Witberg Wind Energy Facility and associated infrastructure, Western Cape Province

Motivation for amendment of Environmental Authorisation

DEA Ref.: 12/12/20/1966/AM6

November 2018

Figure 4.6: Witberg difference in increased viewshed between previously authorised turbine specifications and layout, and the amended 27 turbine specifications and layout.

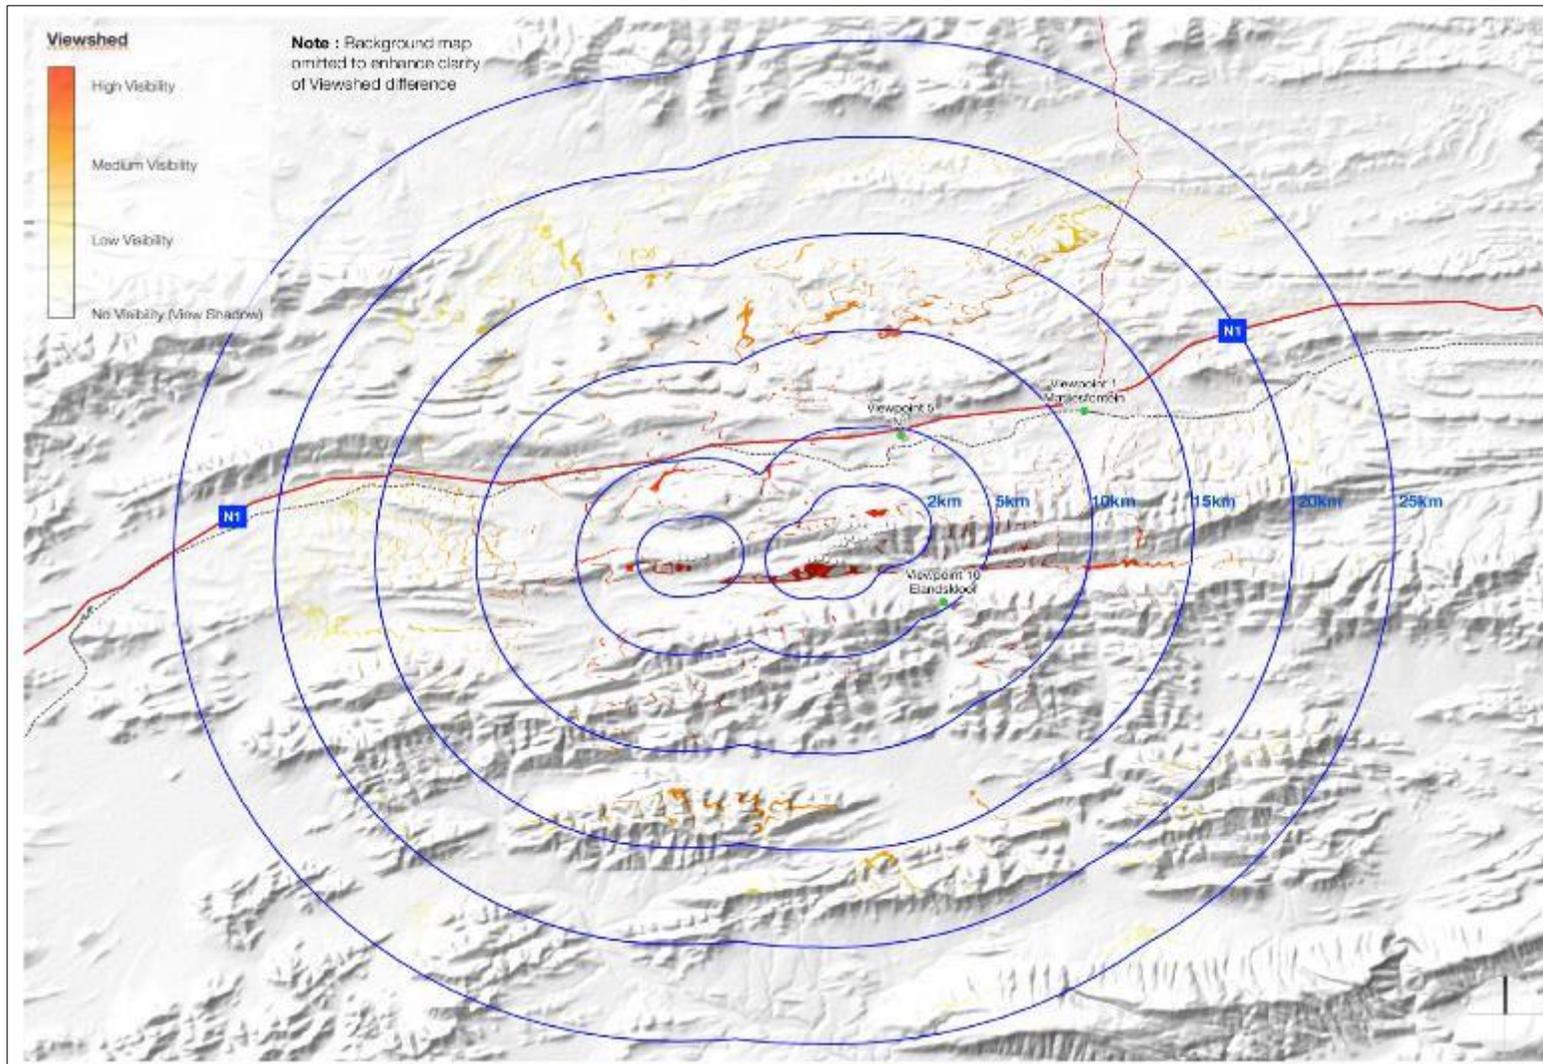
The analysis indicated that the proposed amendments would result in a negligible change to the viewshed (zone of visual exposure) as indicated in **Figure 4.6**. Photomontages have also been prepared to indicate the visibility of the amended proposals from selected viewpoints, (**Figures 4.7 to Figure 4.9**).
